ADDENDUM
NO. 1

July 27, 2026

MERRILLVILLE HS CULINARY AND MEETING AREA RENOVATIONS AND MERRILLVILLE CSC CENTRAL OFFICE ADDITION AND RENOVATION PROJECT

This Addendum consists of pages ADD 1-1 through ADD 1-5 and attached and attached Addendum No. 1 from Gibraltar Design dated July 24, 2026, and consisting of 8 pages, revised Specification Section 08 71 00 - Door Hardware and 47 Drawings.

DRAWING
UNIT "T" FIRST FLOOR FINISH PLAN

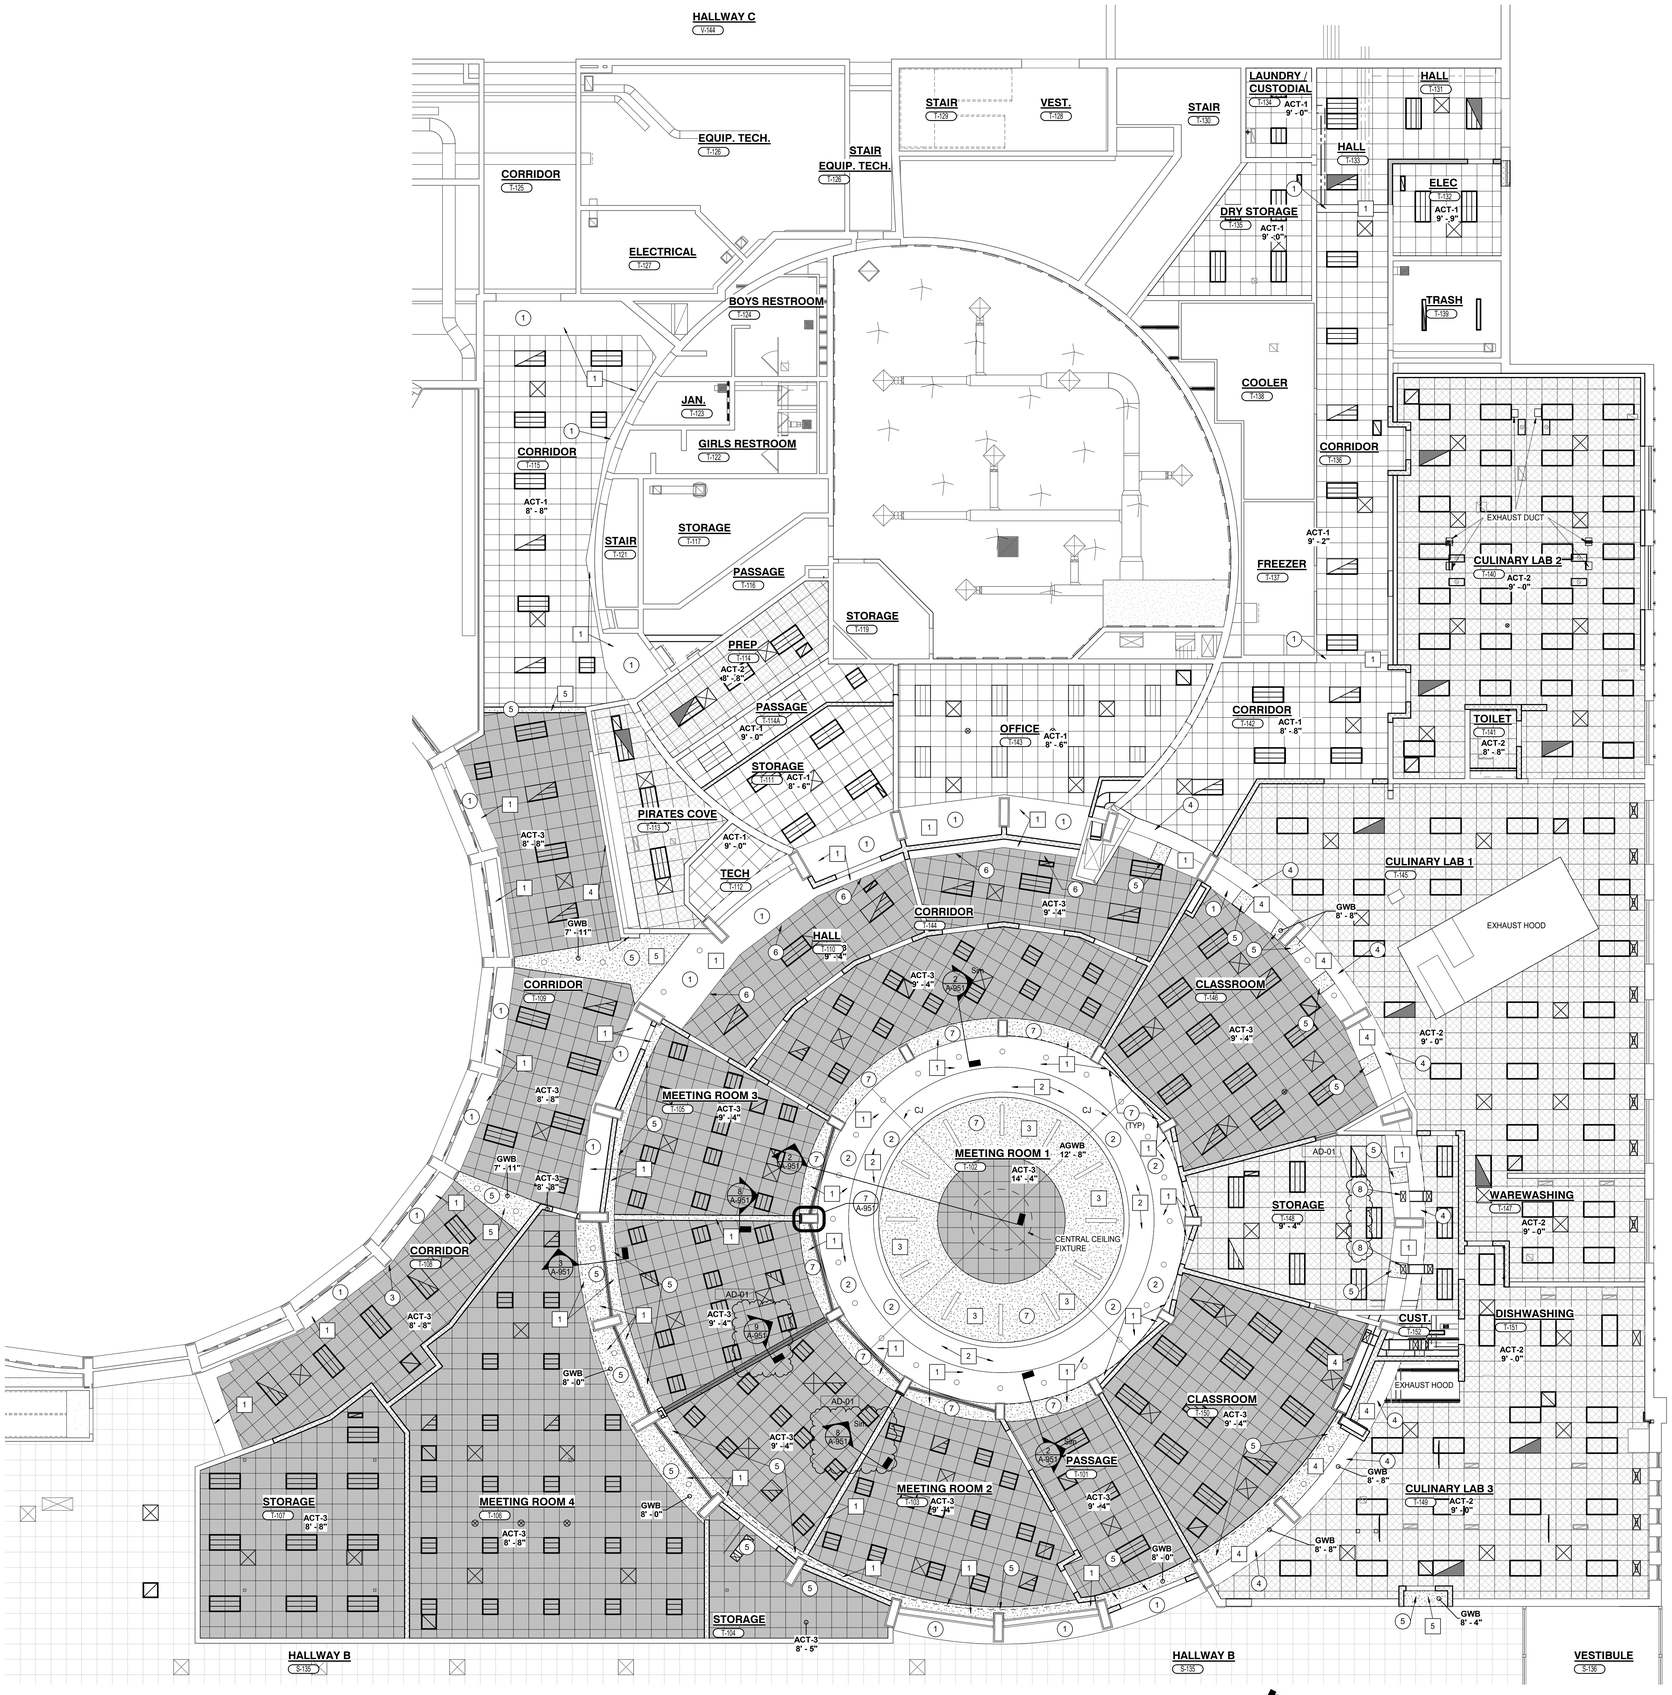
14. Sheet A-821

A. Refer to revised, full-size drawing, included in this Addendum, for revisions.
   1. Added plan notes 23 and 24 to plan notes. See plan for locations.
   2. Revised Office T-143 finishes.

DRAWING
UNIT "T" FIRST FLOOR REFLECTED CEILING PLAN

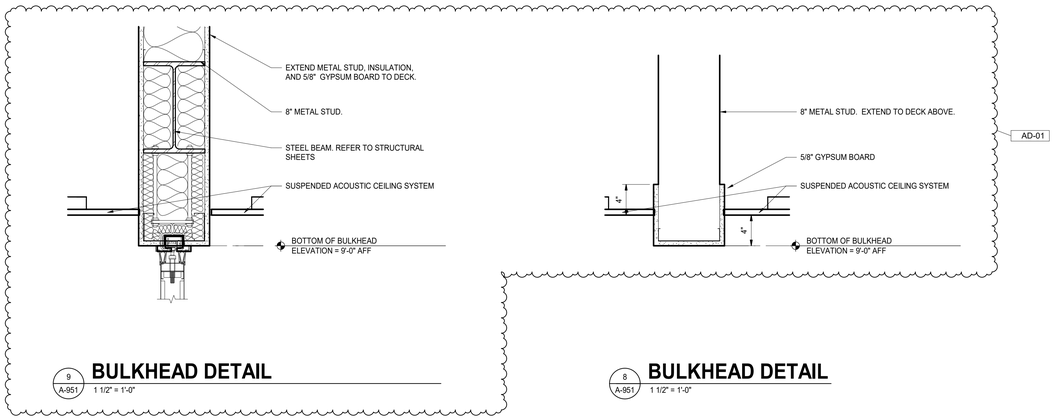
15. Sheet A-921

A. Refer to revised, full-size drawing, included in this Addendum, for revisions.
   1. Added section references in Meeting Room 3 T-105.
   2. Added plan note 8 to plan notes. See plan for locations.

3 A-951 **WALL SECTION**
1 1/2" = 1'-0"

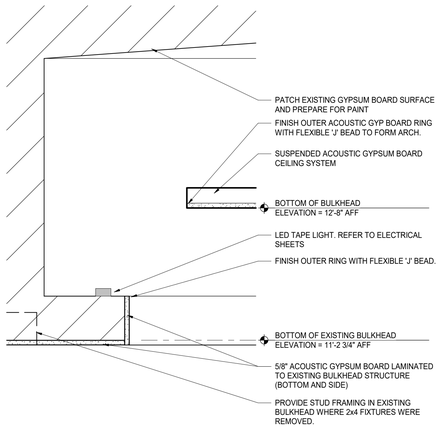
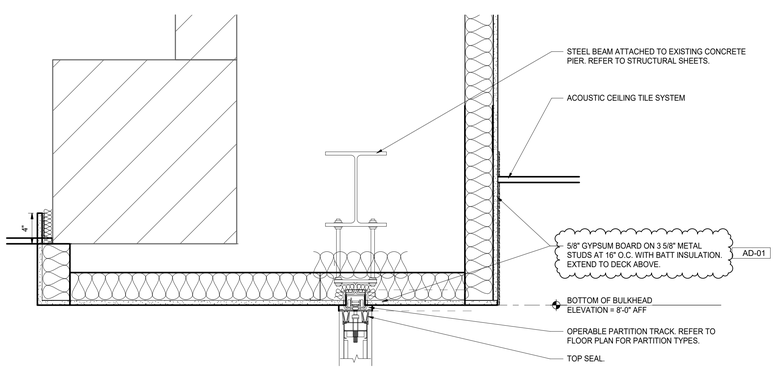
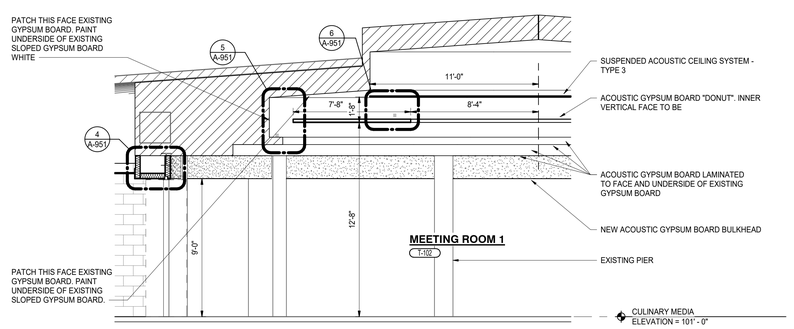
16. Sheet A-951

A. Refer to revised, full-size drawing, included in this Addendum, for revisions.
   1. Added and revised bulkhead details 8/A-951 and 9/A-951.
   2. Revised note on detail 3/A-951.

DRAWING
CULINARY VENTILATION DETAILS

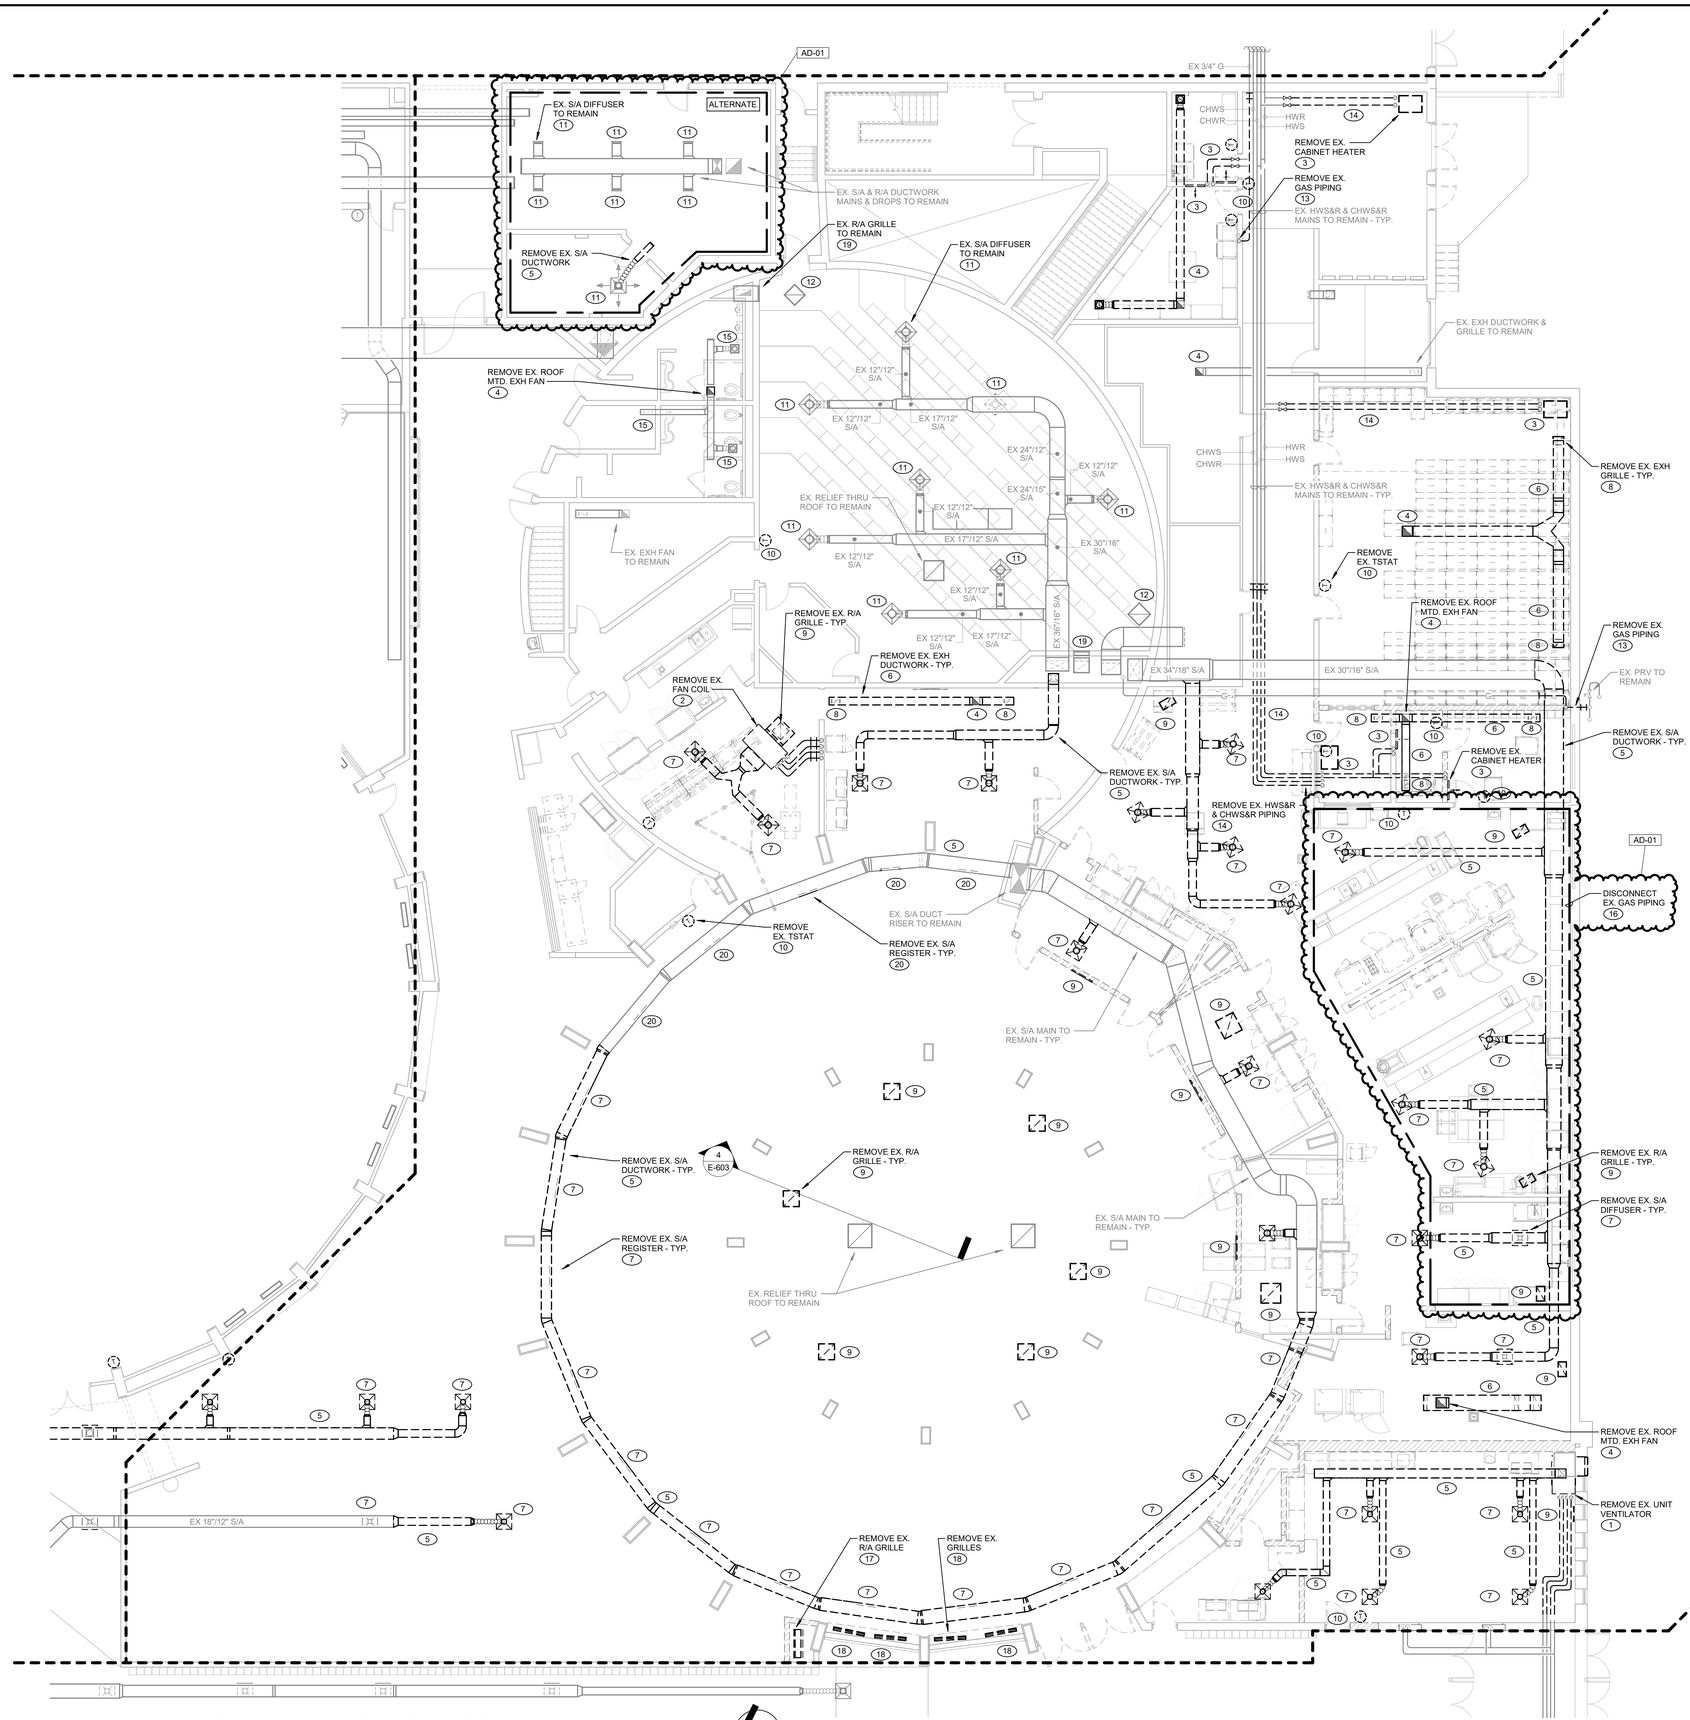
18. Sheet FS4.01

A. Refer to revised, full-size drawing, included in this Addendum, for revisions.
   1. Delete all references to the Ansul Fire Protection System. This system is not required.

DRAWING
UNIT "T" MECHANICAL FIRST FLOOR DEMOLITION PLAN

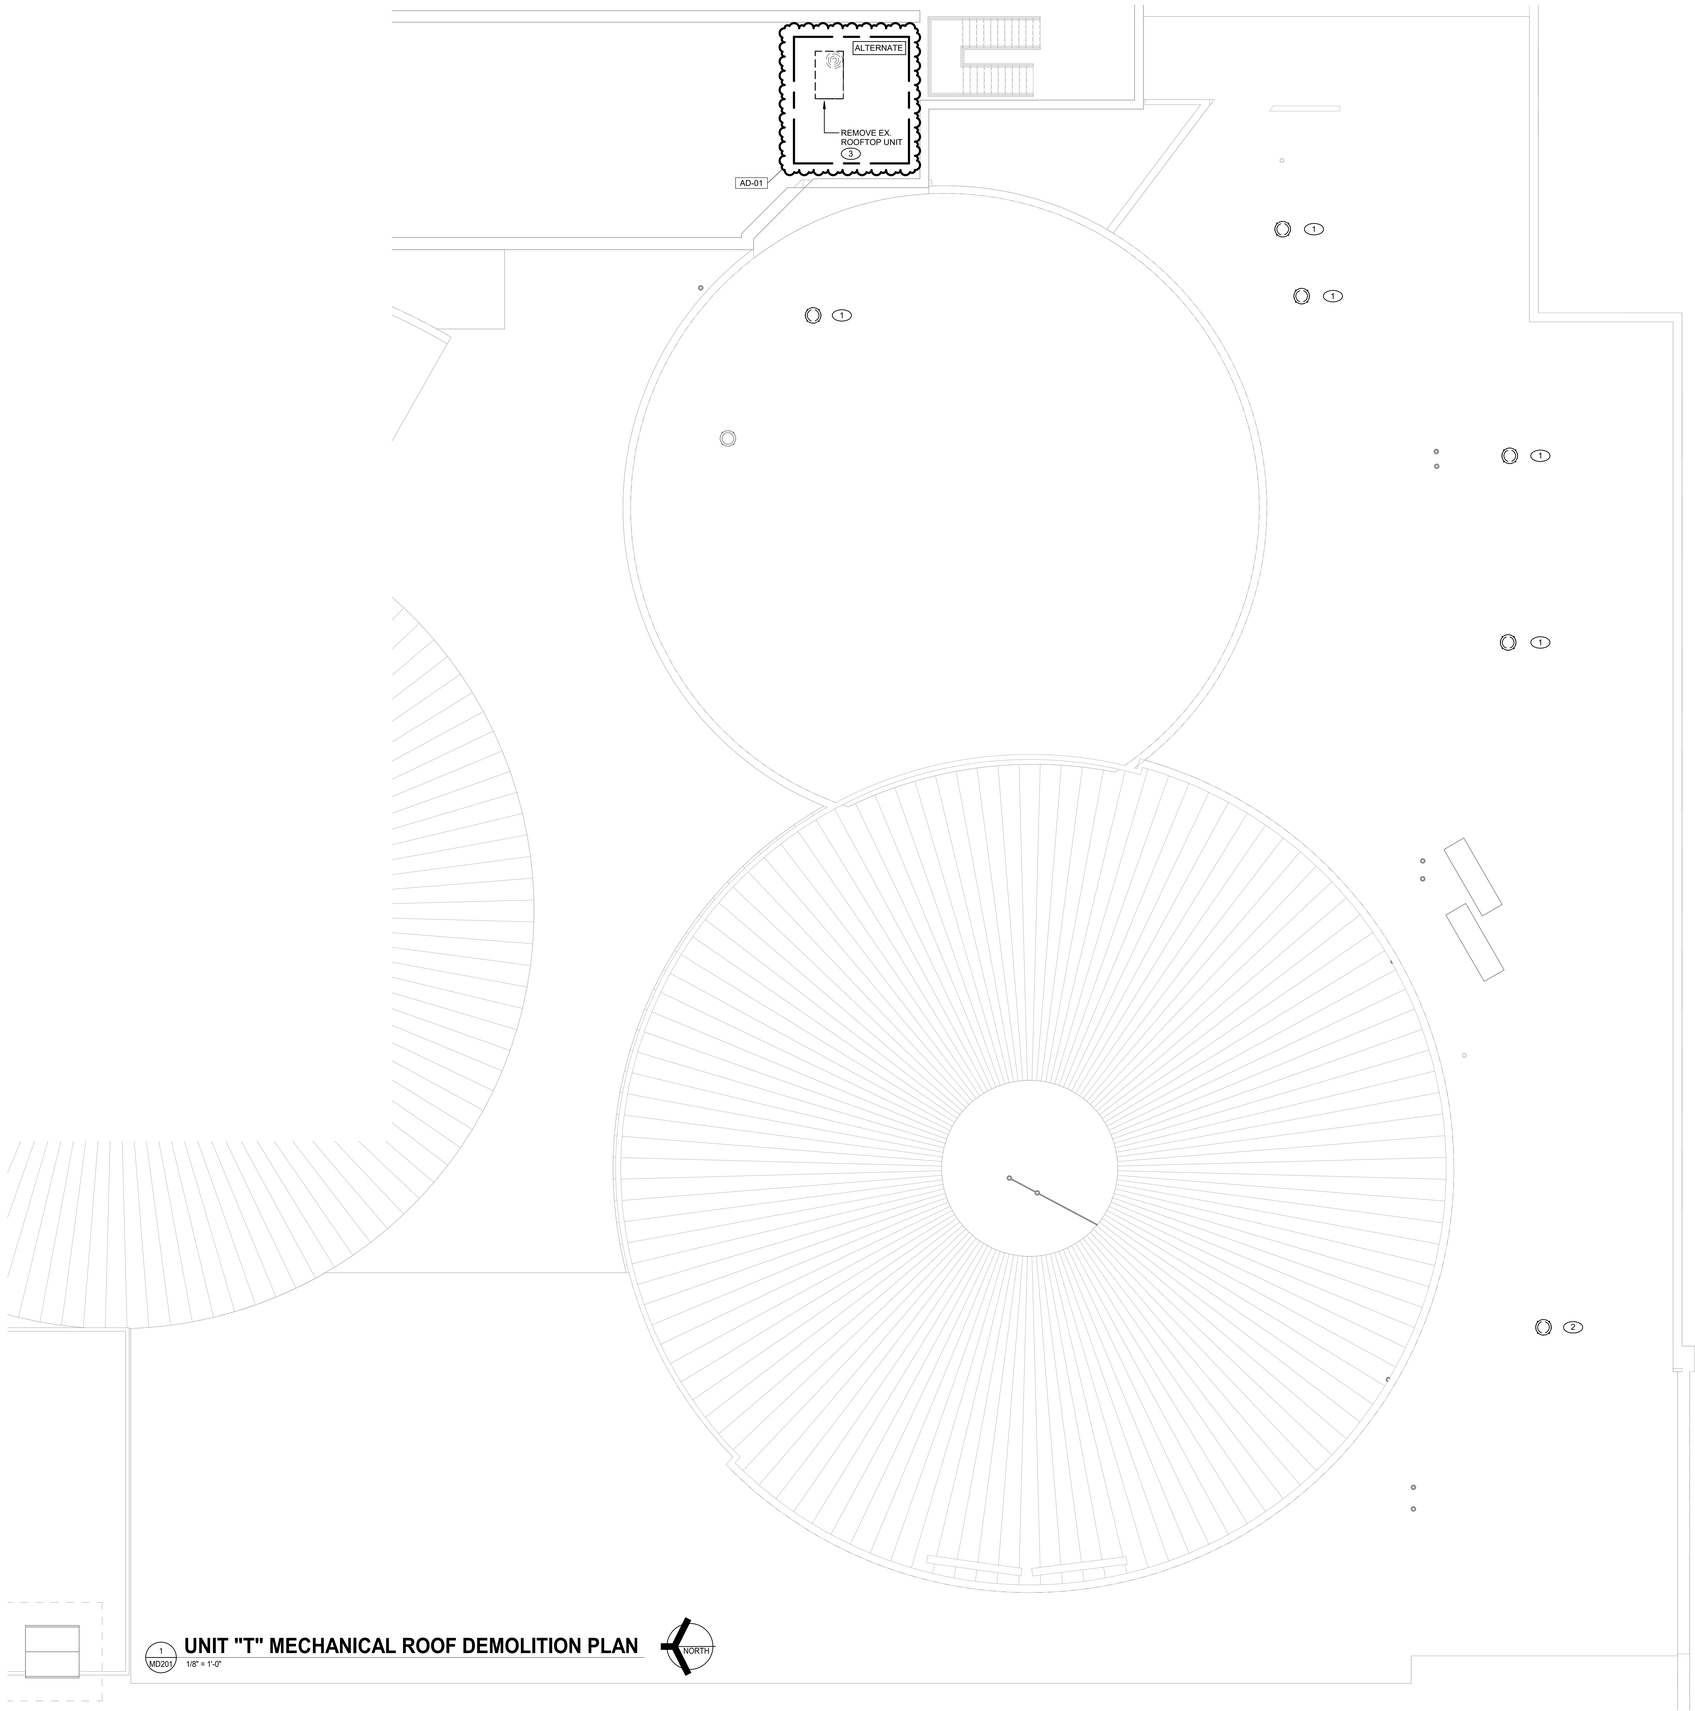
23. Sheet MD121

A. Refer to revised, full-size drawing, included in this Addendum, for revisions.
   1. Revised ductwork and diffusers in equipment technology room.
   2. Added note for existing gas piping and kitchen equipment.
